Access Compliance Report

Public Rights-of-Way

(Curb Ramps)

Intersection ID: 6932	Main Street: OLD_MT_HOLLY_RD	Cross Street: WEST_AV	Location: E
ADA ID: 6C5E07377A87	Ramp Type: Perp	Initial Pass/Fail: Fail	Overall Compliance: No
Severity Score: 33.75			
Codes/Mitigation Info/Possible Solution		Field Measurements/Component Compliance

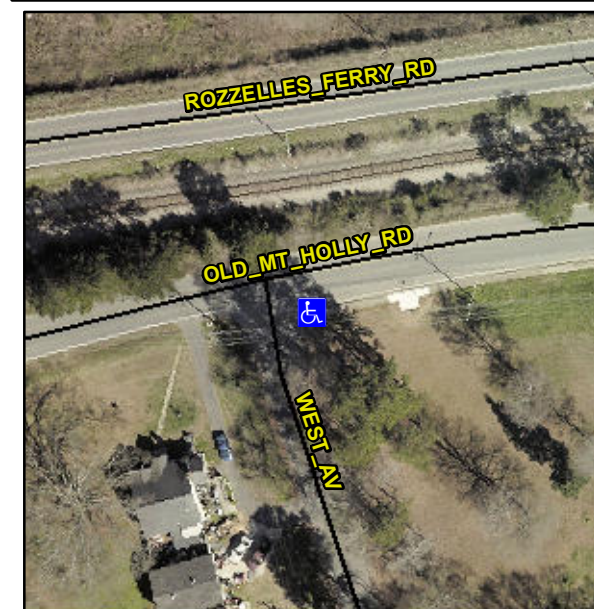
Not Found, R304.5.1, R304.5.3

Compliance	Description	Data	Compliance	Description	Data
N/A	Ramp Length (in)	57.0	Yes	Ramp Slope (%)	5.1
No	Ramp Width (in)	47.5	No	Ramp XSlope (%)	7.6
N/A	Flare Type LT	N/A	N/A	Flare Type RT	N/A
N/A	Flare Slope LT (%)	N/A	N/A	Flare Slope RT (%)	N/A
N/A	Flare Traversable LT?	N/A	N/A	Flare Traversable RT?	N/A
N/A	Landing Length (in)	N/A	N/A	DWS Provided?	N/A
N/A	Landing Width (in)	N/A	N/A	DWS Contrast?	N/A
N/A	Landing Slope (%)	N/A	N/A	DWS Length (in)	N/A
N/A	Landing X Slope (%)	N/A	N/A	DWS Full Width?	N/A
N/A	Landing Curb? (Y/N)	N/A	N/A	DWS Offset (in)	N/A
N/A	Shared Landing?	N/A			
N/A	Gutter Ponding?	N/A	N/A	Gutter Slope (%)	N/A
N/A	Gutter Lip Ht (in)	N/A	N/A	Gutter X Slope (%)	N/A
N/A	Painted X Walk1?	No	N/A	Painted X Walk2?	N/A
	X Walk 1 Direction	To W		X Walk 2 Direction	N/A
N/A	X Walk 1 Width (in)	N/A	N/A	X Walk 2 Width (in)	N/A
	X Walk 1 Slope (%)	2.5		X Walk 2 Slope (%)	N/A
	X Walk 1 X Slope (%)	4.8		X Walk 2 X Slope (%)	N/A

Remove & Replace Entire Ramp.
